M E M O R A N D U M

SUBJECT: Laurel Hills Ltd – Proposed Residential Development – WSP Opus response to Second Review dated 8 Jan 2019.

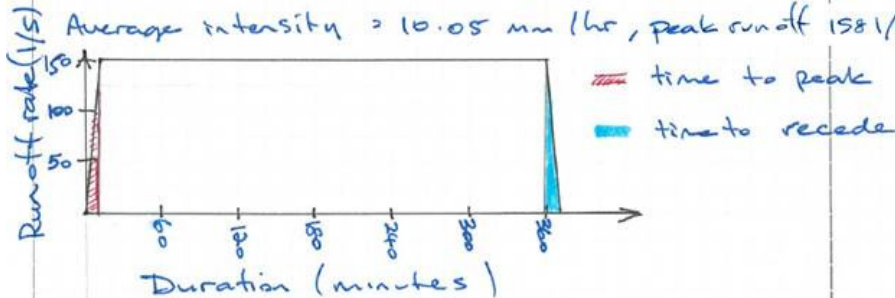
Stormwater

As the catchments are relatively small our view is Rational formula is appropriate for calculating peak run-off. Modified Rational formula is appropriate for calculating volume.

Updated volume calculations are shown below.
